Well Name: FULLER 14/11 H3GB FED COM	Well Location: T26S / R29E / SEC 14 / SENE / 32.0427376 / -103.9484361	County or Parish/State: EDDY / NM
Well Number: 2H	Type of Well: OIL WELL	Allottee or Tribe Name:
Lease Number: NMNM011038	Unit or CA Name:	Unit or CA Number:
US Well Number: 3001553575	Operator: MEWBOURNE OIL COMPANY

Type of Action: APD Change

Procedure Description: Mewbourne Oil Company request that the following changes be made to the approved APD for the Fuller 14/11 H3GB Fed Com #2H (APD ID: 10400080419)... Change well name from Fuller 14/11 H3GB Fed Com #2H to Fuller 14/11 Fed Com #565H Change BHL from 100' FNL & 2310' FEL (Sec 11) to 100' FNL & 2200' FEL (Sec 11) Request permission for BOP break testing and offline cementing

PECOS DISTRICT DRILLING CONDITIONS OF APPROVAL

LOCATION VERIFICATION MAP

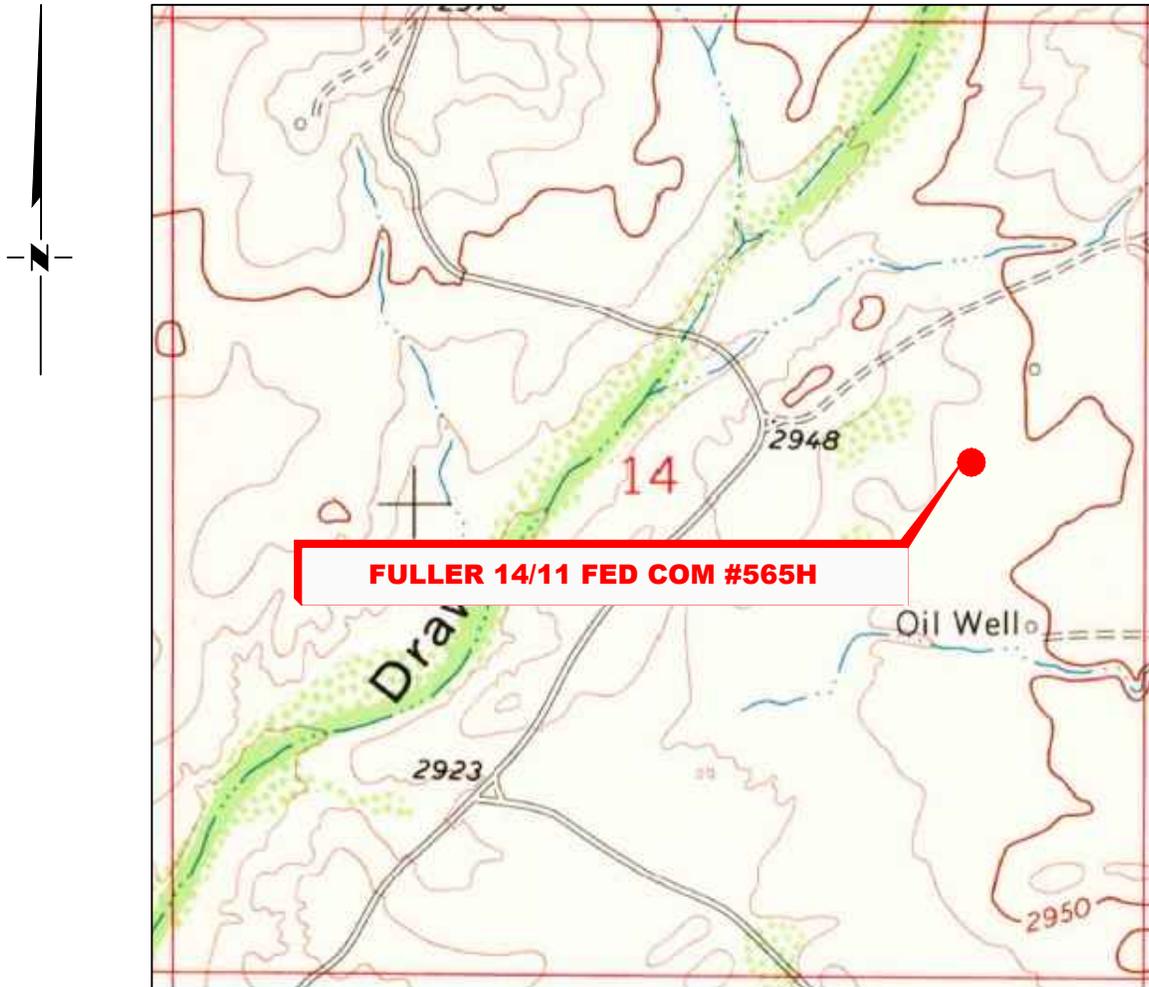
1	NAME CHANGE	5/16/24
NO.	REVISION	DATE
JOB NO.: LS21080826D		
DWG. NO.: 21080826D-2

VICINITY MAP

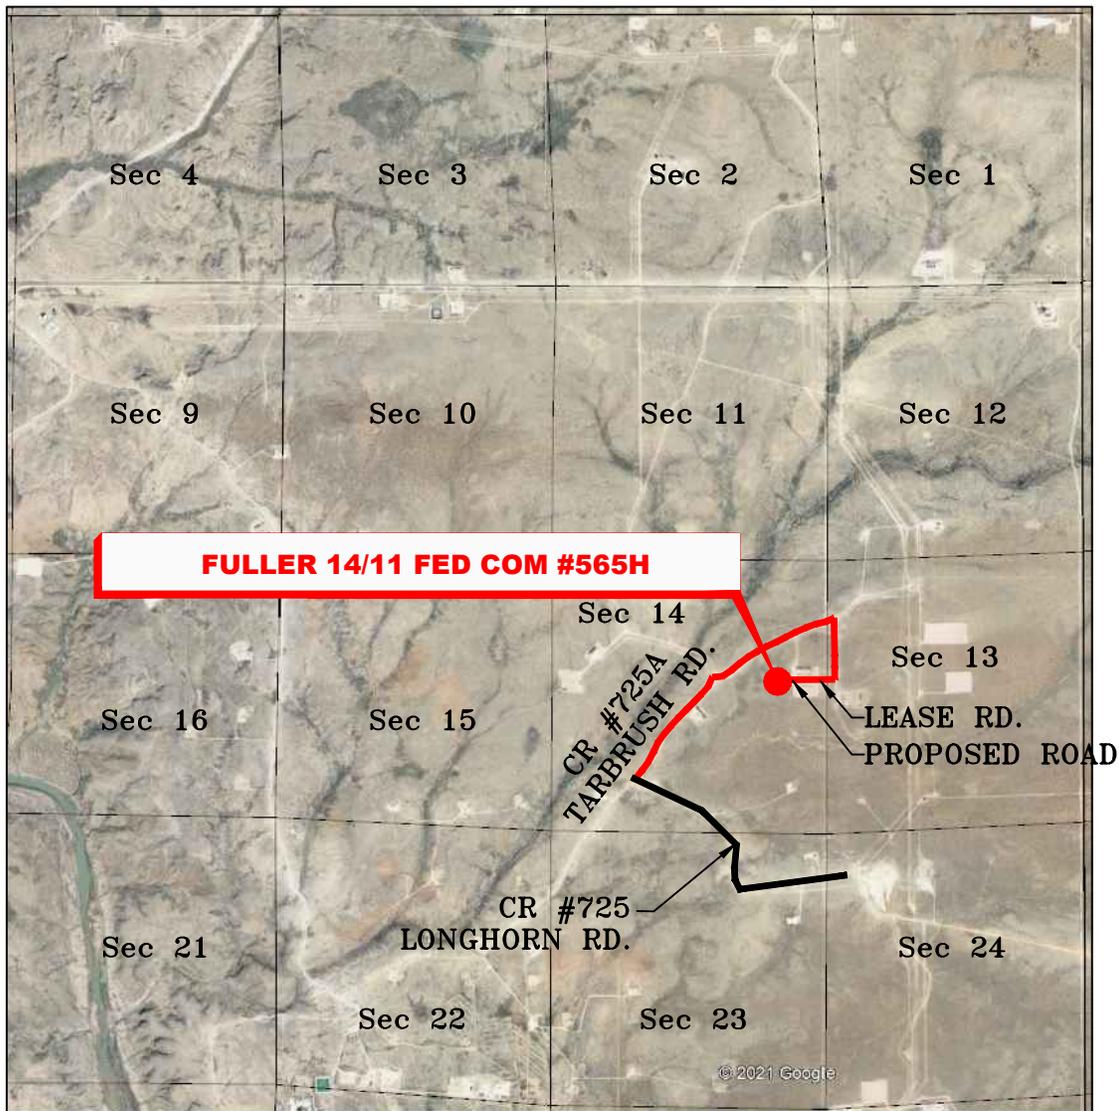
1	NAME CHANGE	5/16/24
NO.	REVISION	DATE
JOB NO.: LS21080826D		
DWG. NO.: 21080826D-3

**MEWBOURNE OIL COMPANY
FULLER 14/11 FED COM #565H
(2390' FNL & 895' FEL)
SECTION 14, T26S, R29E
N. M. P. M., EDDY CO., NEW MEXICO**

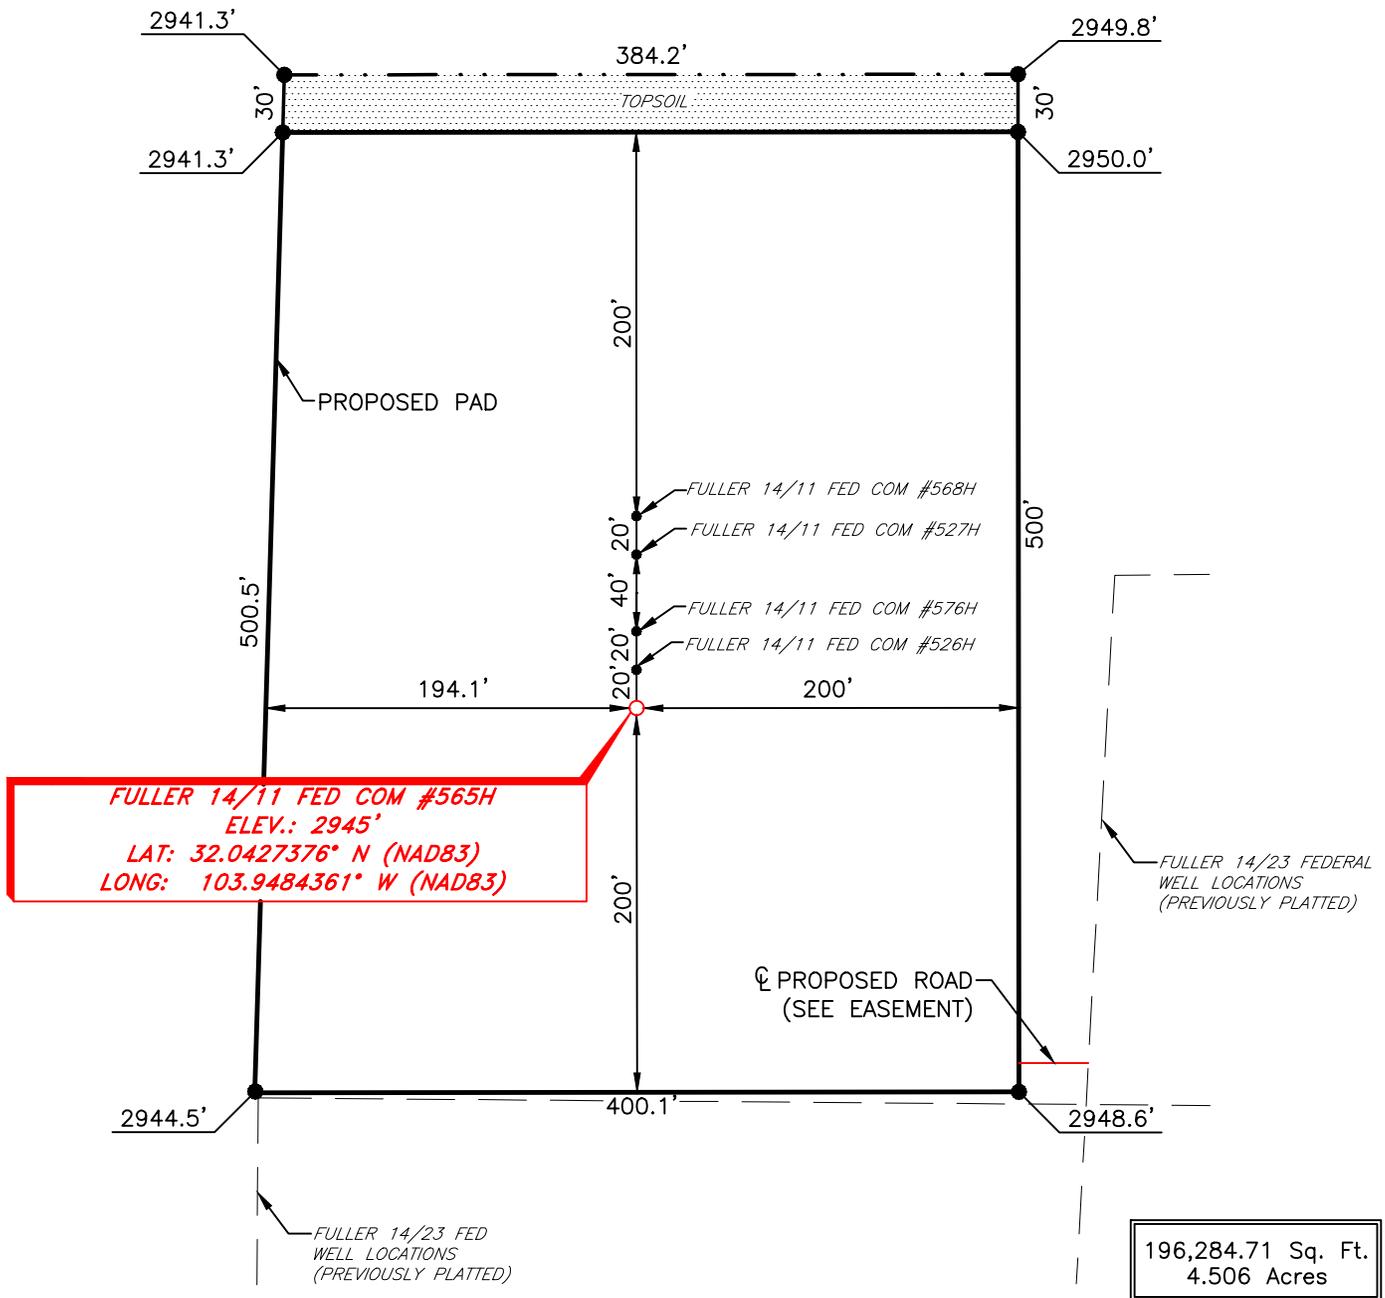
1	NAME CHANGE	5/16/24
NO.	REVISION	DATE
JOB NO.: LS21080826D		
DWG. NO.: 21080826D-4
